Project	IEEE 802.16 Broadband Wireless Access Working Group < http://ieee802.org/16 >	
Title	Service Primitives for Accounting	
Date Submitted	2005-07-11	
Source(s)	Yun Won Chung, PhD	yun.chung@etri.re.kr
	Jee Hyeon Na,	jhna@etri.re.kr
	Sang Ho Lee, PhD	leesh@etri.re.kr
	ETRI 161, Gajeong-dong, Yuseong-gu, Daejeon, 305-700, Korea	
		Voice: +82-42-860-5244 Fax: +82-42-861-1966
Re:	Call for Comment on P802.16g Baseline Document	
Abstract	This contribution proposes service primitives for accounting.	
Purpose	The document should be considered during the resolution of comments on the baseline document.	
Notice	This document has been prepared to assist IEEE 802.16. It is offered as a basis for discussion and is not binding on the contributing individual(s) or organization(s). The material in this document is subject to change in form and content after further study. The contributor(s) reserve(s) the right to add, amend or withdraw material contained herein.

Service Primitives for Accounting

Proposed Text Changes

Fig.4 - Accounting Primitive Initiated by BS

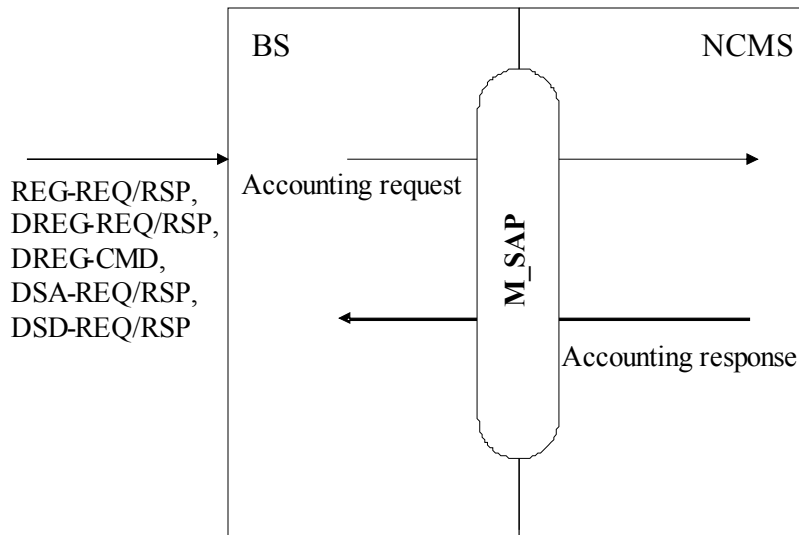
[Modify section 14.5.3 as follow]

14.5.3.1 Accounting Procedure

Accounting primitives consists of Accounting request and Accounting response, as shown in Figs. 4 and 5. Accounting attributes in Accounting request and Accounting response are basically based on the attributes defined in RADIUS or Diameter, and new accounting attributes such as Service Flow Identifier, Service Class Name, Service Flow Scheduling Type, and Minimum Reserved Traffic Rate are additionally defined for IEEE802.16 WMAN specific application. Thus, the proposed accounting can accommodate various services characteristics of IEEE 802.16 WMAN.
